**Addendum No. 1 to IFB 18-53**

To: All Parties on Record with the City of Somerville as Holding **IFB 18-53 Nibble Co-Working Kitchen Construction**

Re: Answer Questions, Revised Qualifications, Other Revisions

1 REFLECTED CEILING PLAN  
1/2"=1'-0"

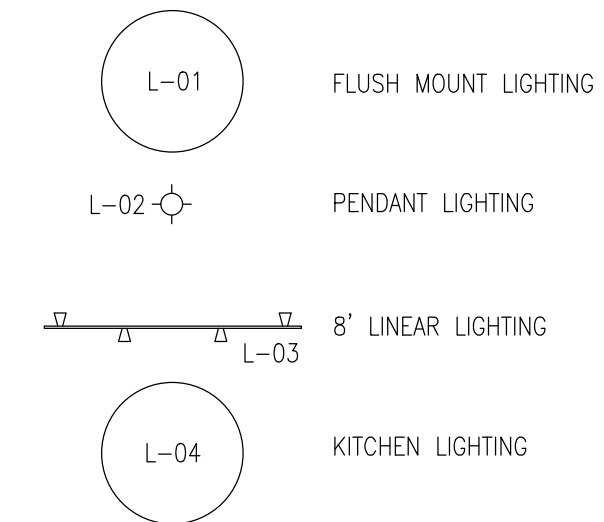
During the pre-bid walkthrough, it was brought to the City's attention that the building contractor has installed two new beams along the ceiling. Please see notes in the attached drawing.
